MOD2022/0471

SUMMARY OF CHANGES:

Project Name
1955 Pittwater Rd., Bayview

Drawing Title
Entry Floor Plan

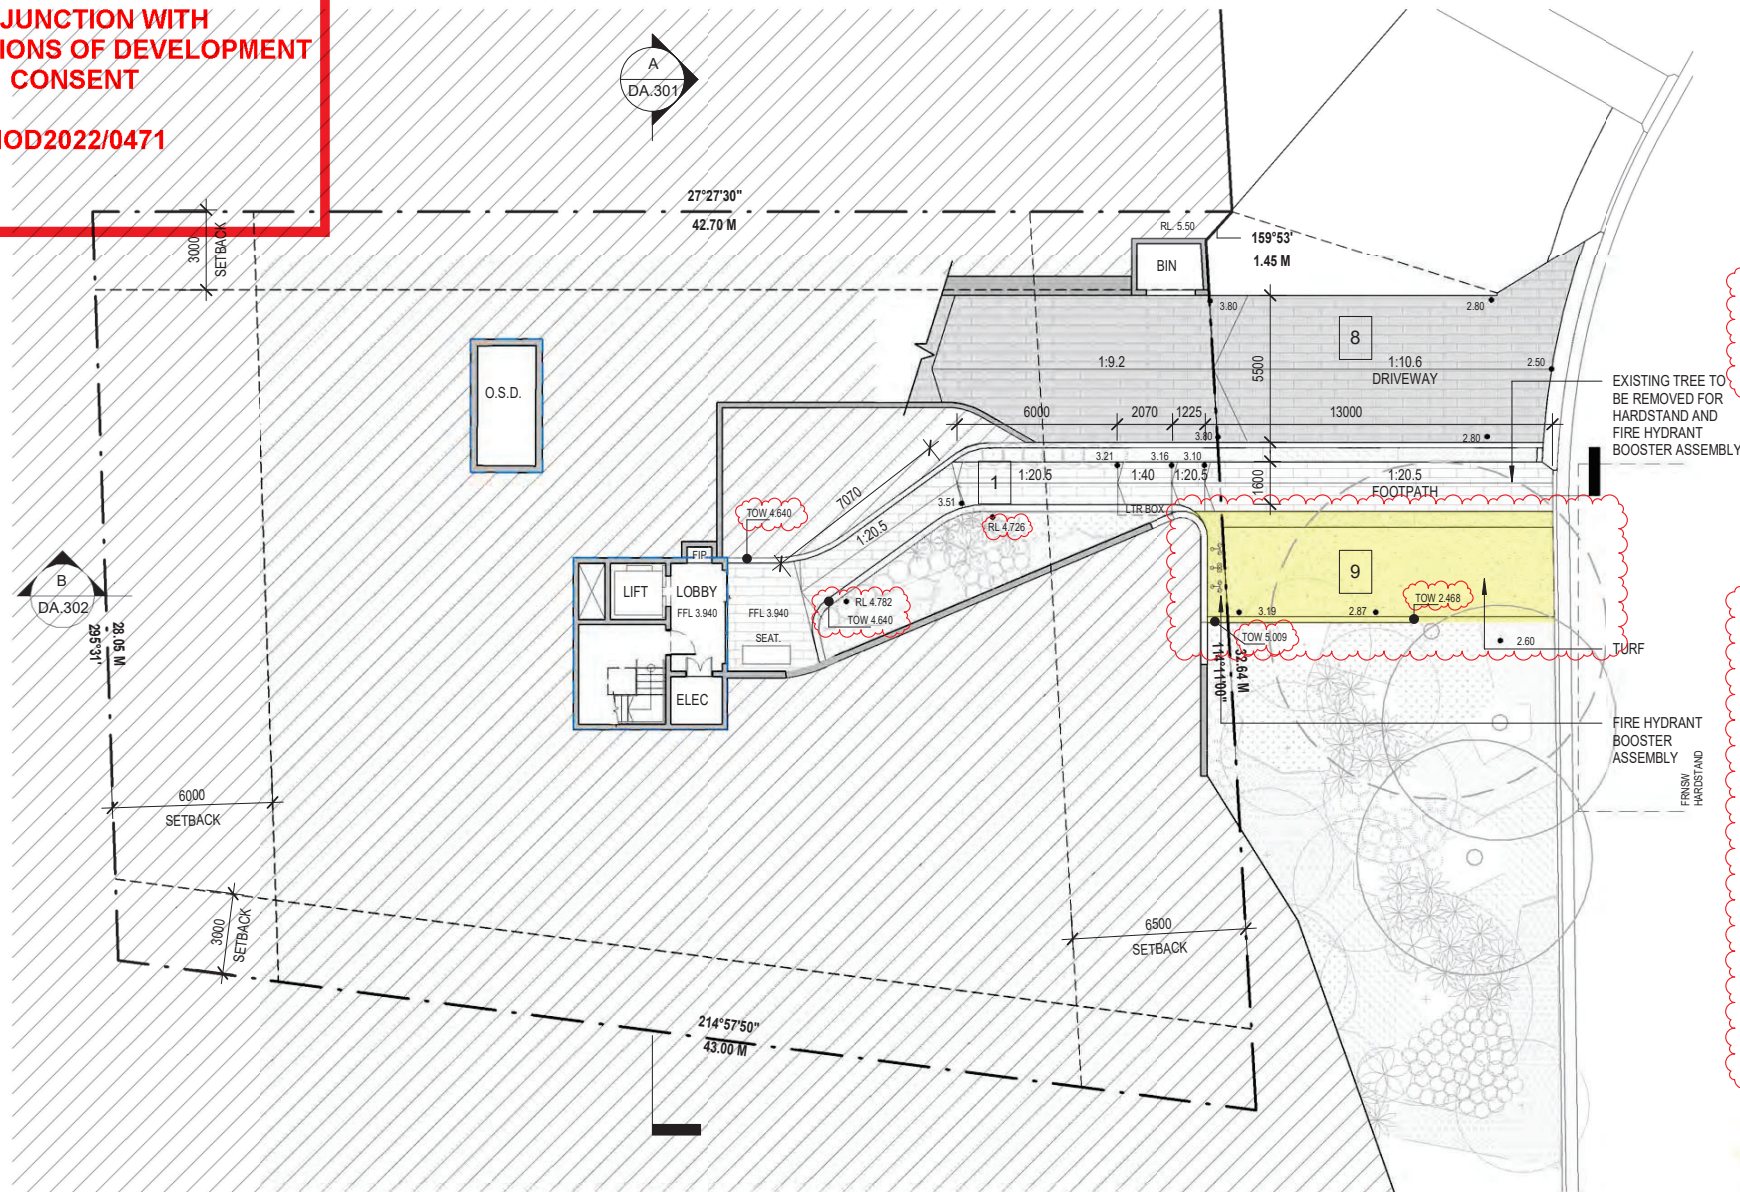
- 1. Entry Pedestrian Ramp** - Increased pedestrian ramp width to 1600mm for accessibility
- 2. Building Entry** - New awning and vertical louvre screen to increase sense of entry.

- 3. Balcony Articulation** - New curved balconies for improved aesthetics. Increase in outdoor private open space area and solar access for improved amenity

- 4. Fencing** - New fencing to provide safety and security
- 5. Roof** - New rooftop plant enclosure to comply with services requirements
- 6. First Floor Roof Deck/ Landscaping** - Change in configuration of First Floor roof deck to integrate with overall building aesthetics. New landscape buffer around perimeter of First Floor roof deck for improved privacy and softening of built form

- 7. Roof & Floor RL** - Adjustment in floor-to-floor heights to reflect structural and building services requirements.
- 8. Vehicular Access** - Design development to comply with accessibility & Australian Standards.

- 9. FRNSW Requirement** - to provide handstand & fire hydrant booster assembly, requiring removal of tree T3 (Refer to Arborist Report).
- 10. Carpark Floor Plan** - Parking re-configuration within approved footprint.

- 11. Lower Ground Floor Plan** - Increase in Unit 4 storage area to accentuate recess and alignment between the two modulated built forms. Louvered door and panels for maintenance and ventilation. New landscaped terrace to integrate with cascading balconies above and overall building aesthetics.

- 12. Unit layouts** - Internal reconfiguration and increase in unit size for improved amenity.
- 13. Elevations** - Removal of wall break in east elevation of Units 3 and 4. Revised façade and window treatments associated with plan amendments

- 14. Boundary Fence** - 1.8m high painted fencing capped and lapped in Dulux 'Winter Fog'
- 15. Vertical Screening** - Continuation of vertical screening over lift shaft to accentuate recess between the two modulated built forms

- 16. Proposed Terrace Extension**

Drawing Title
Lower Ground Floor Plan

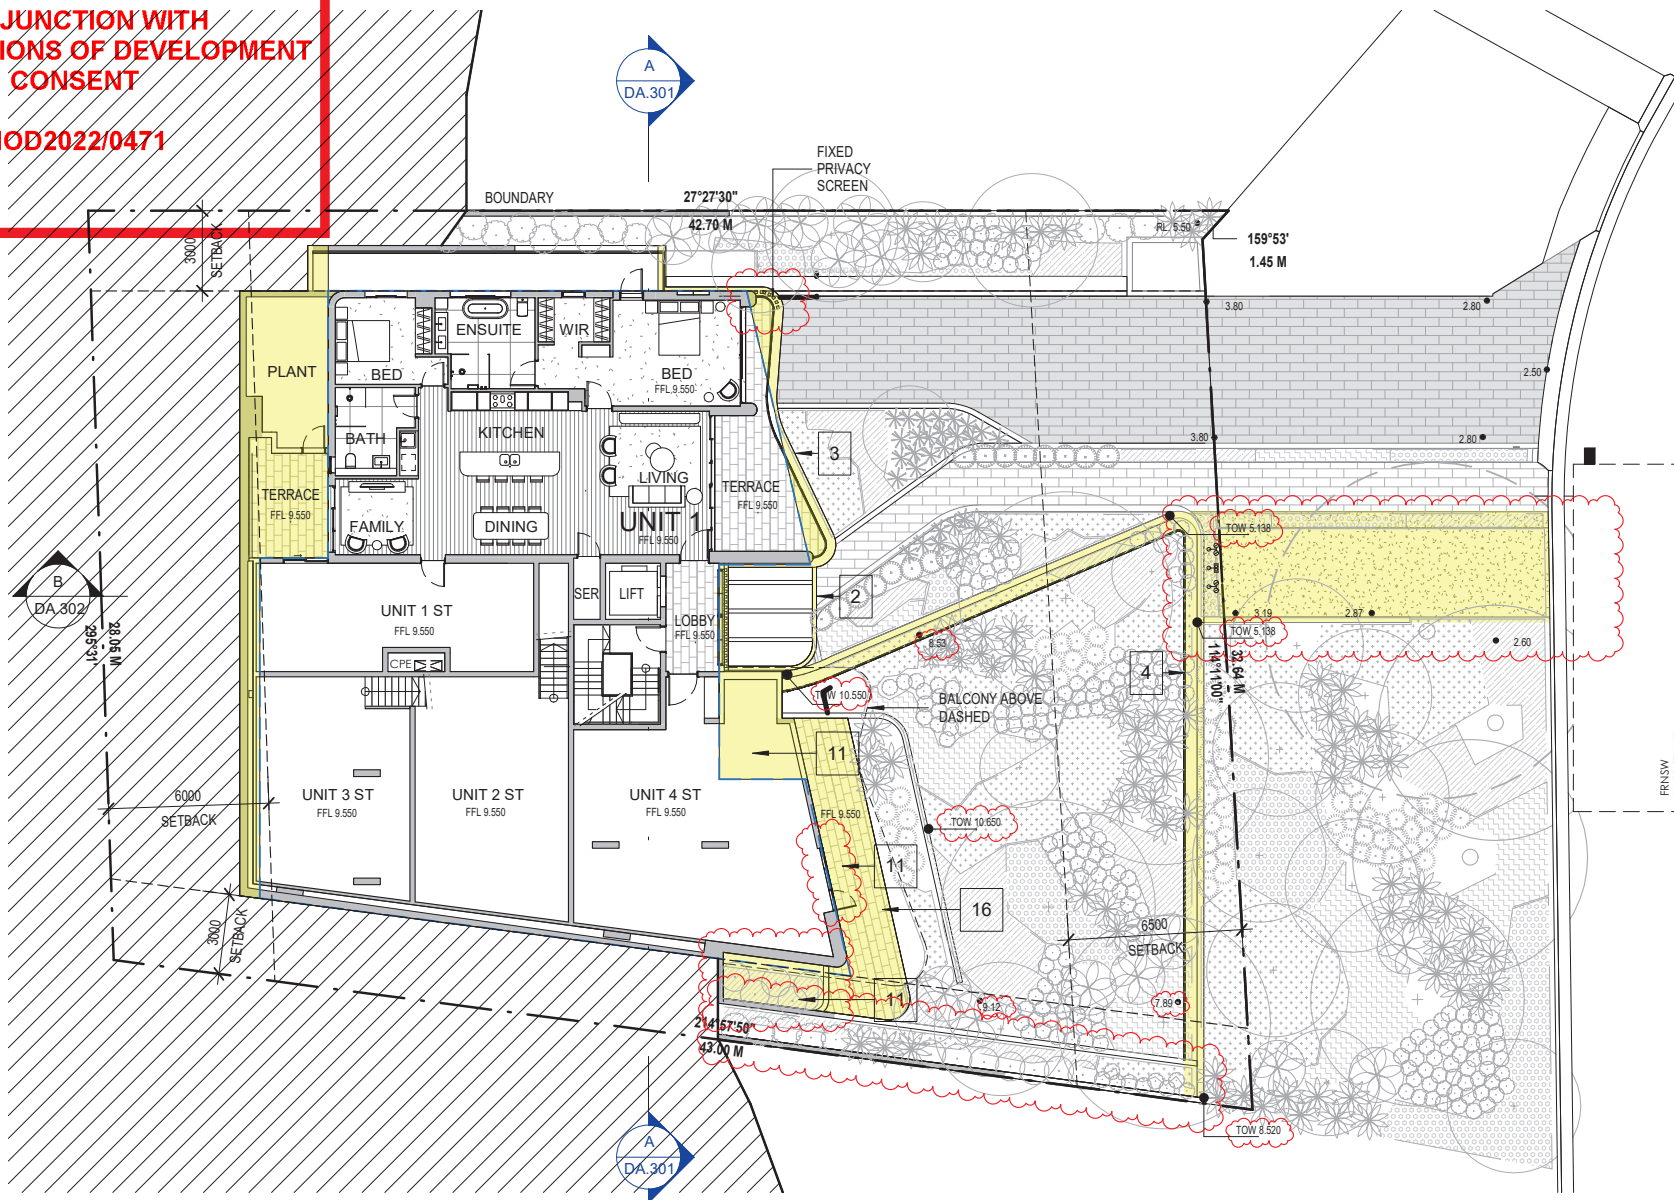
- 11. Lower Ground Floor Plan** - Increase in Unit 4 storage area to accentuate recess and alignment between the two modulated built forms. Louvered door and panels for maintenance and ventilation. New landscaped terrace to integrate with cascading balconies above and overall building aesthetics.

Drawing Title
First Floor Plan

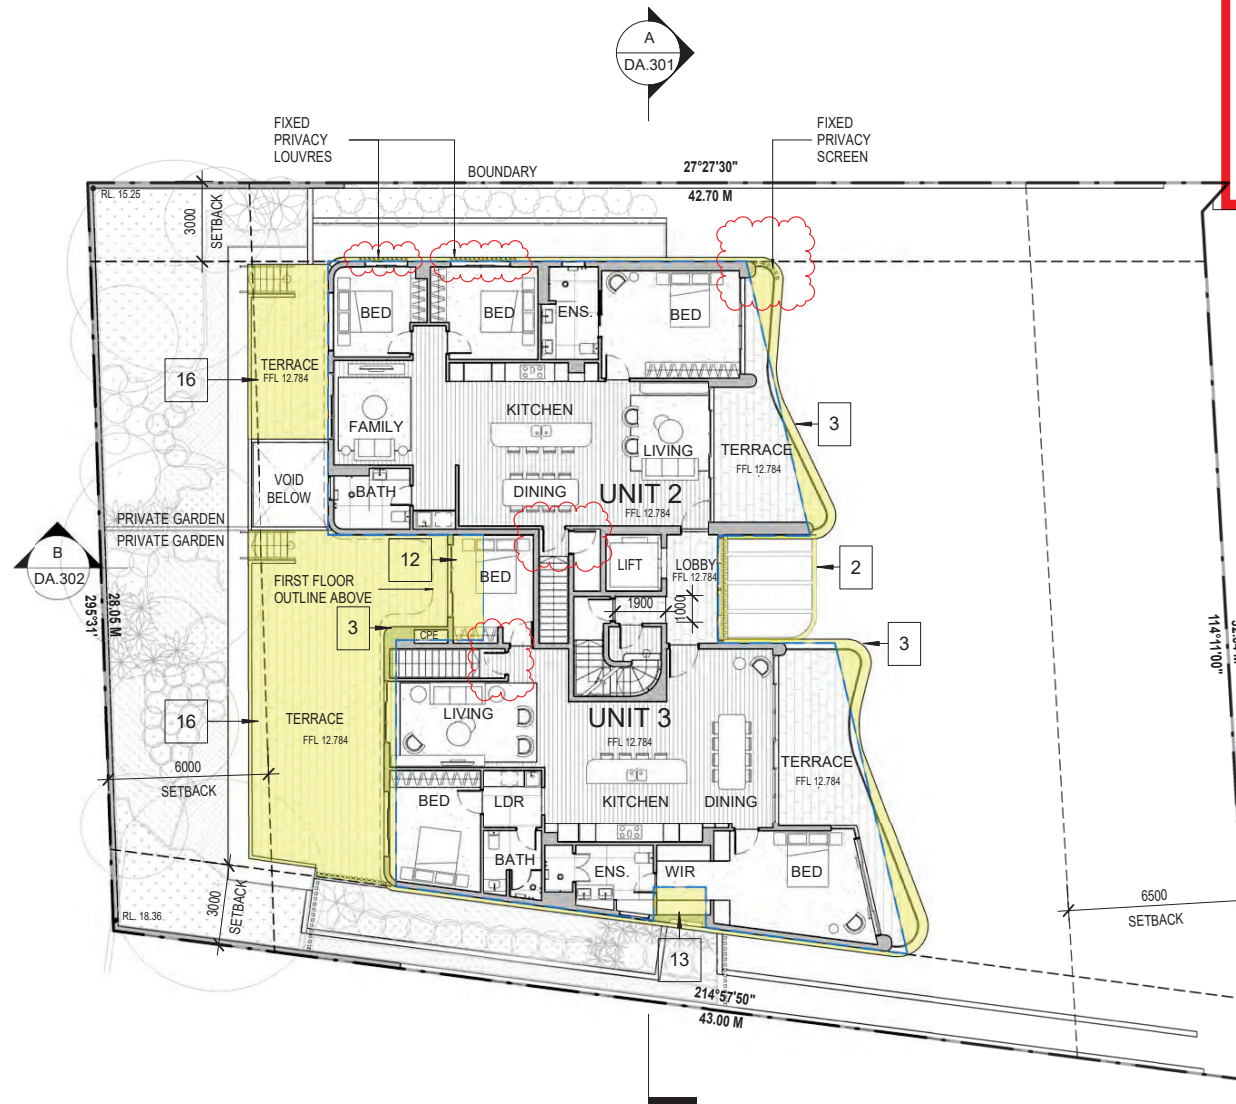
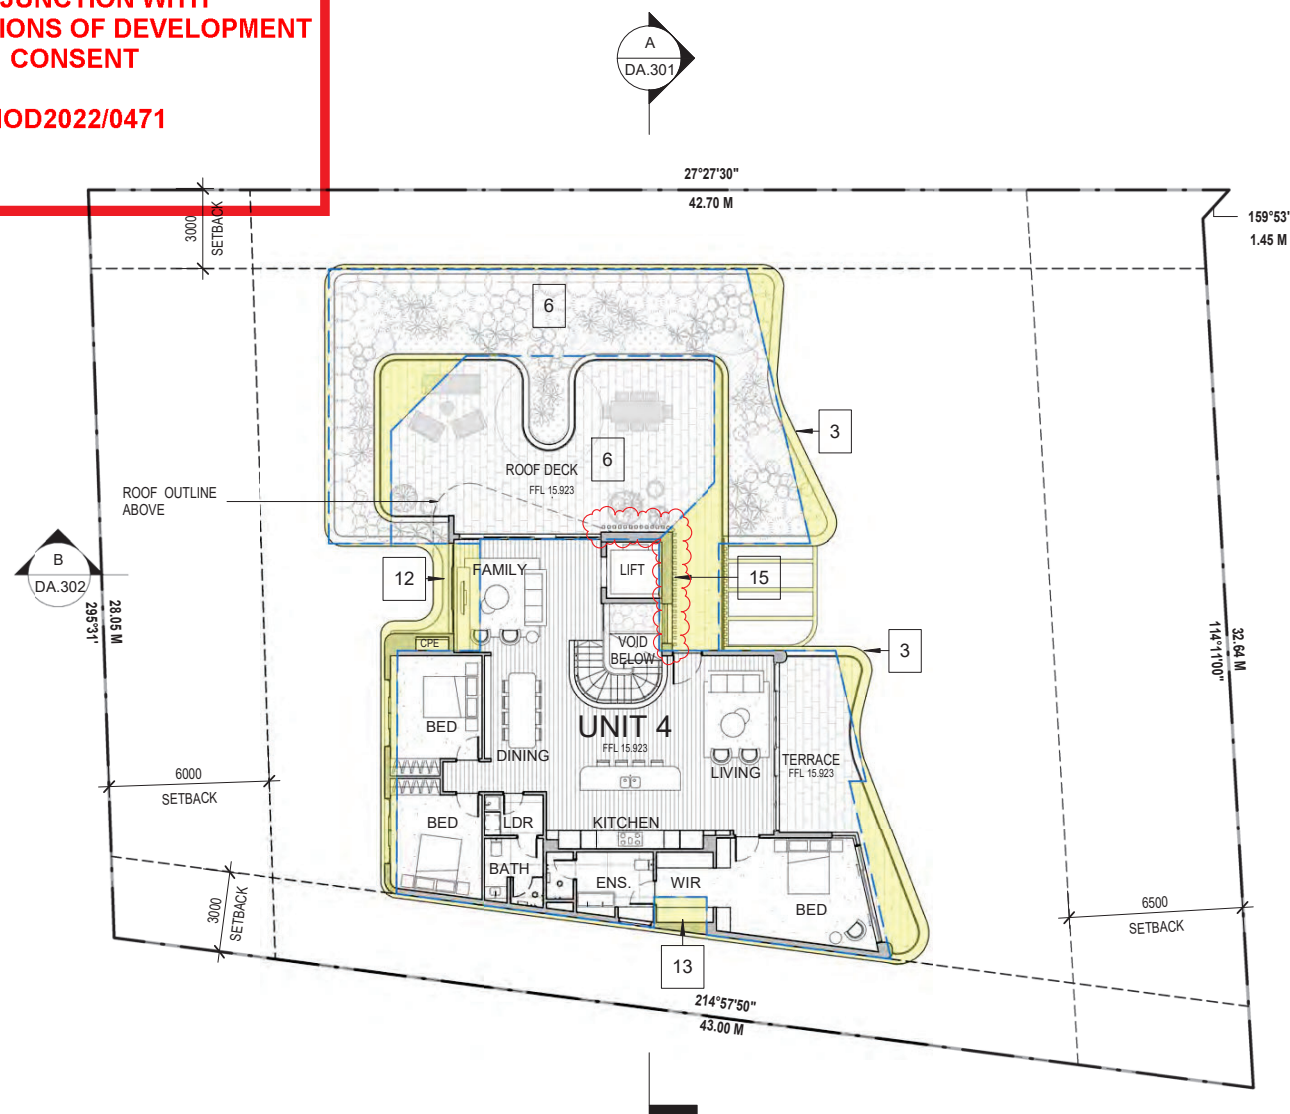
- 4. Fencing** - New fencing to provide safety and security
- 5. Roof** - New rooftop plant enclosure to comply with services requirements
- 6. First Floor Roof Deck/ Landscaping** - Change in configuration of First Floor roof deck to integrate with overall building aesthetics. New landscape buffer around perimeter of First Floor roof deck for improved privacy and softening of built form

Drawing Title
North Elevation

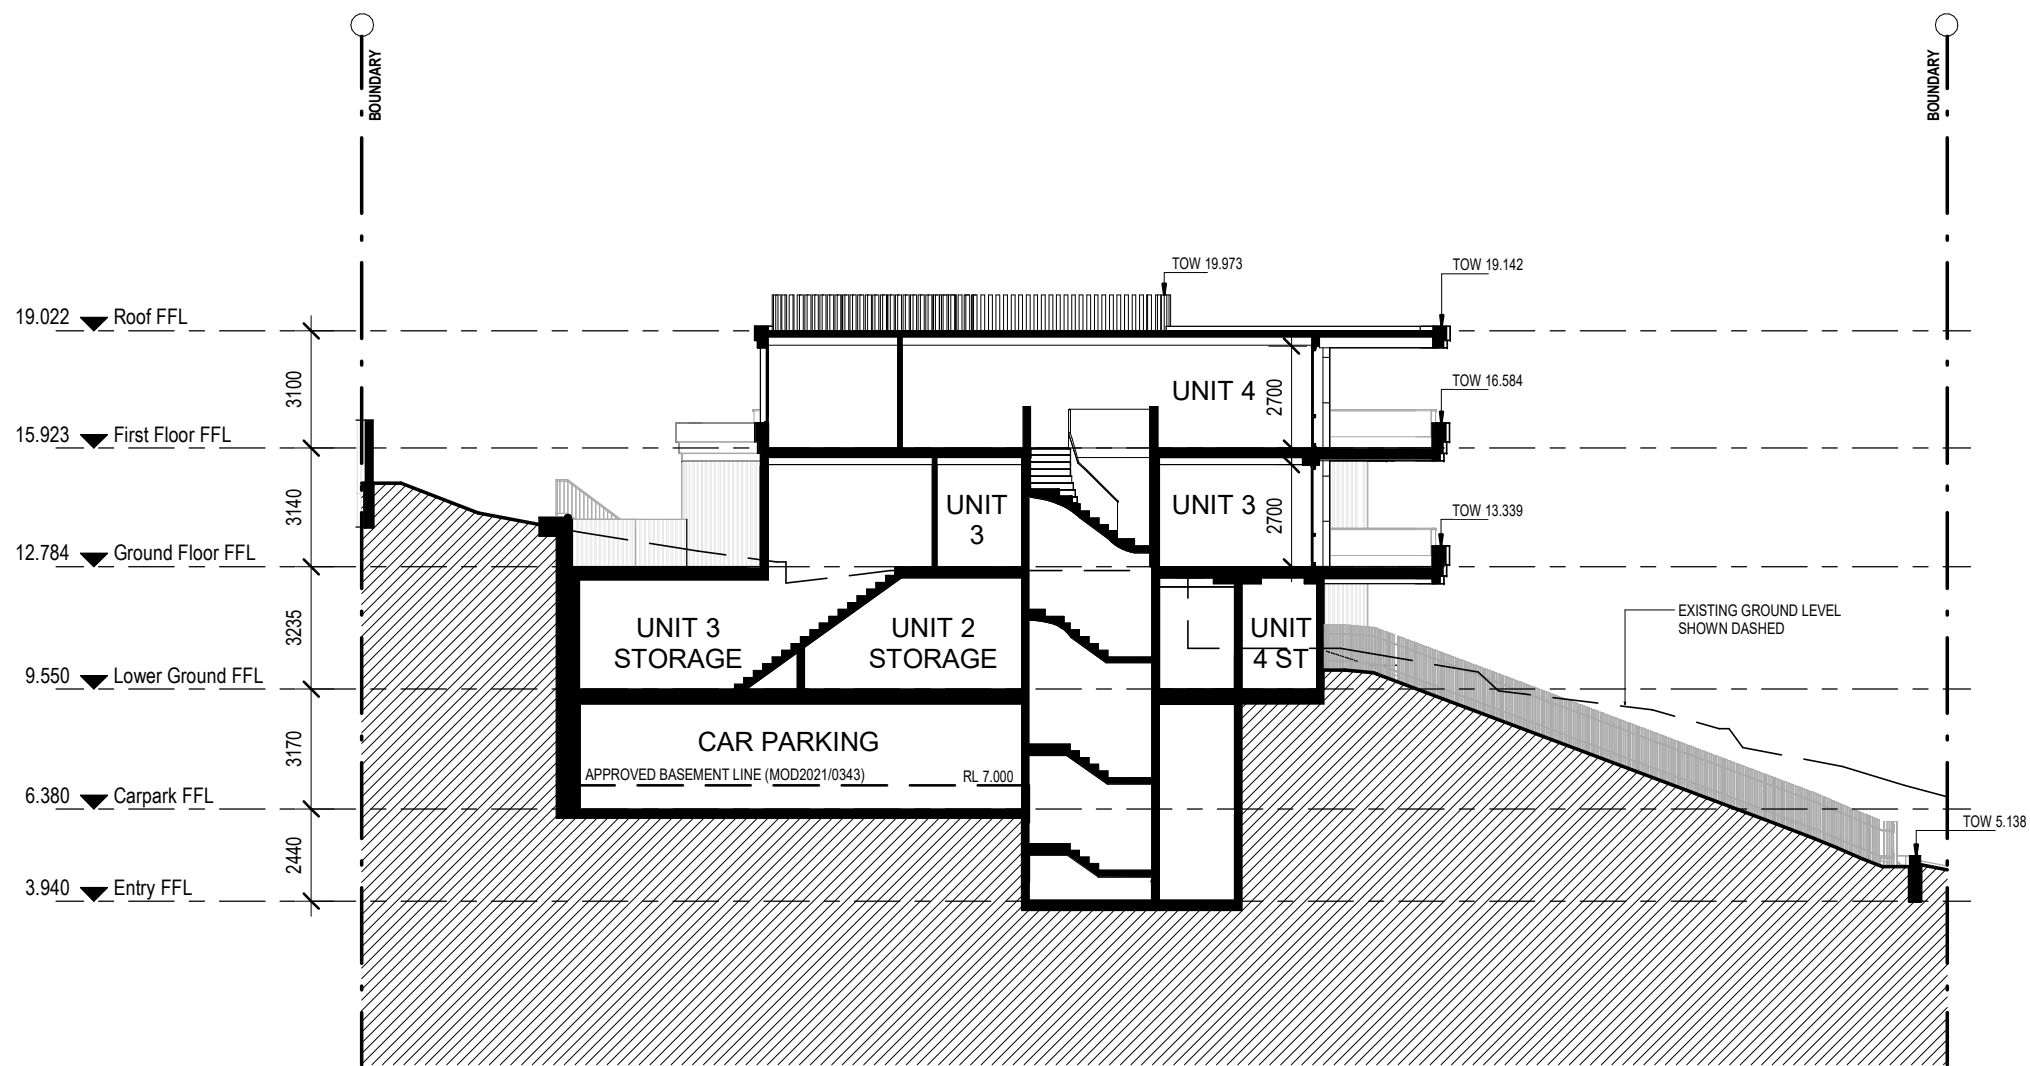
- 9. FRNSW Requirement** - to provide handstand & fire hydrant booster assembly, requiring removal of tree T3 (Refer to Arborist Report).

Fire Hydrant Booster Assembly
(to future supplier details)

Booster assemblies are manufactured to conform to the requirement of AS2419 & to relevant local authorities. All components comply to the requirements of AS2419. Any fabricated components are Hot Dipped Galvanised as required in AS2419. Backflow prevention devices can be supplied and designed into assemblies. Backflow devices comply to AS2845.1. All components will withstand pressure testing up to 2100kpa. (Note: Fire Brigade test pressure is 1700kpa.) All booster units can be supplied as individual components or fully part assembled.
